Xiaomi Communications Co., Ltd.

Product Equality Declaration

M2503E1

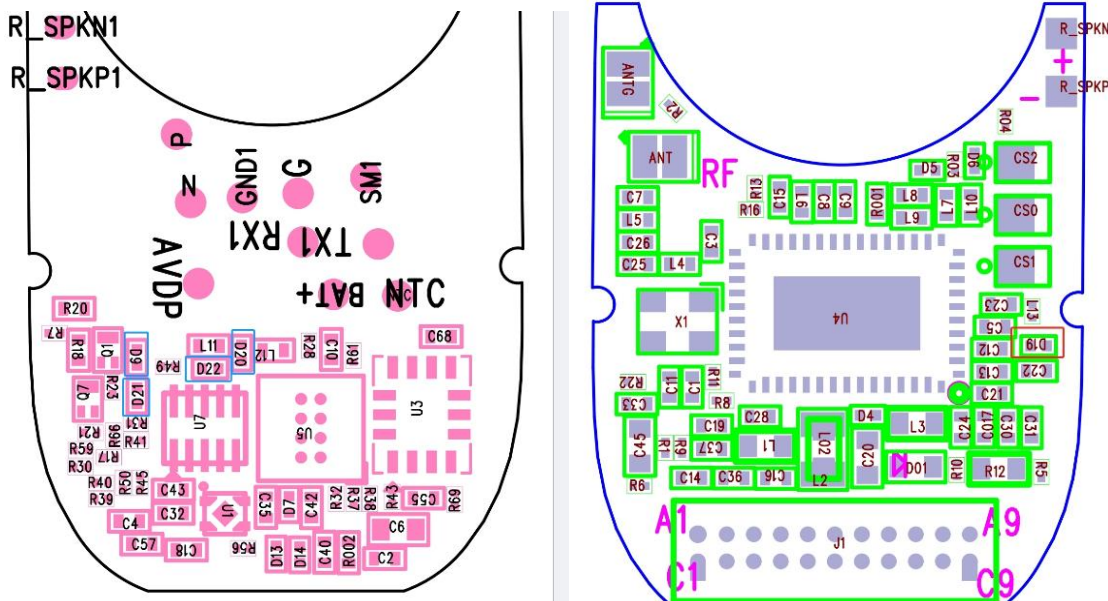
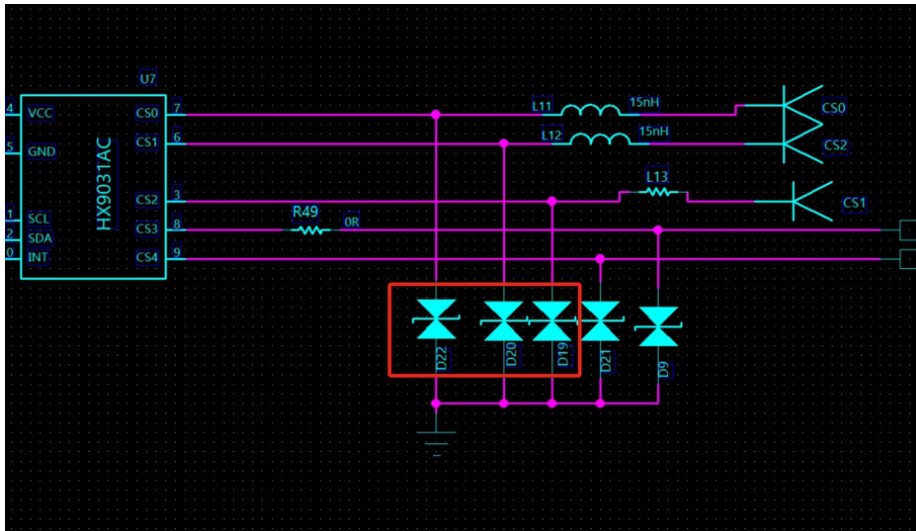
To optimize the performance of the headphones, five ESD (electrostatic discharge) components were removed from the headphone motherboard. This change has no impact on the RF parameters or performance.

Remove component names	Components Placement	Function
WE05DGCMS-BH	D22	Anti-static function
WE05DGCMS-BH	D20	Anti-static function
WE05DGCMS-BH	D19	Anti-static function
WE05DGCMS-BH	D9	Anti-static function
WE05DGCMS-BH	D21	Anti-static function

The battery label of the charging box has been modified in terms of silk-screen printing. Only the specifications of the silk-screen printing have changed, while there are no other differences.
